Access Compliance Report Public Rights-of-Way (Curb Ramps)

Main Street: RANCHWOOD_RD Cross Street: SHELTERWOOD_RD Location: SE

ADA ID: RPAT211013103721 Ramp Type: Type 4 - Parallel Initial Pass/Fail: Fail Overall Compliance: No Severity Score: 2

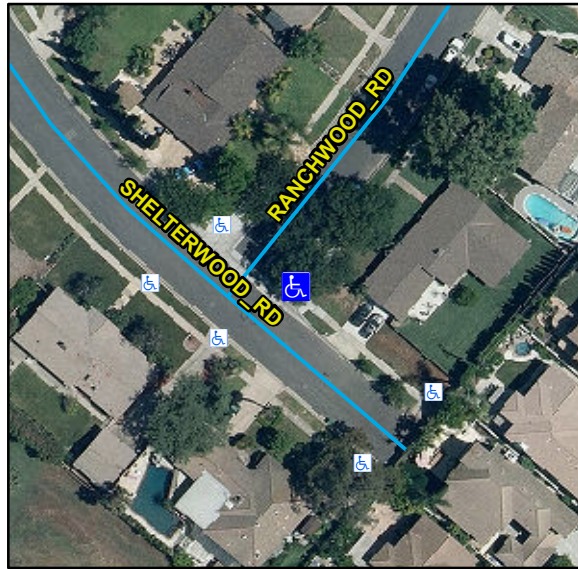
Compliance	Description	Data	Compliance	Description	Data
N/A	Ramp Length LT (in)	124	N/A	Ramp Length RT (in)	105
Yes	Ramp Width LT (in)	84	Yes	Ramp Width RT (in)	77
Yes	Ramp Run Slope LT (%)	7.3	Yes	Ramp Run Slope RT (%)	7.2
Yes	Ramp Cross Slope LT (%)	1.2	No	Ramp Cross Slope RT (%)	3.1
N/A	Landing Present	N/A	N/A	DWS Provided	N/A
N/A	Landing Length (in)	N/A	N/A	DWS Contrast	N/A
N/A	Landing Width (in)	N/A	N/A	DWS Length (in)	N/A
N/A	Landing Run Slope (%)	N/A	N/A	DWS Full Width	N/A
N/A	Landing Cross Slope (%)	N/A		DWS Offset Type	N/A
N/A	Landing Movement Obstructed?	N/A	N/A	DWS Offset Left (in)	N/A
	Landing Movement Type	N/A	N/A	DWS Offset Right (in)	N/A
N/A	Landing Shared	N/A			
N/A	Clear Space	Yes			
N/A	Clear Space To Crosswalk (in)	N/A			
N/A	Marked Crosswalk 1	No	N/A	Marked Crosswalk 2	No
	Crossing 1 Direction	NW		Crossing 2 Direction	SW
	Marked Crosswalk 1 Width (in)	N/A		Marked Crosswalk 2 Width (in)	N/A

Remove & Replace Curb Ramp With Two New Directional Ramps or Equivalent.

R304.5.3, STD 1115
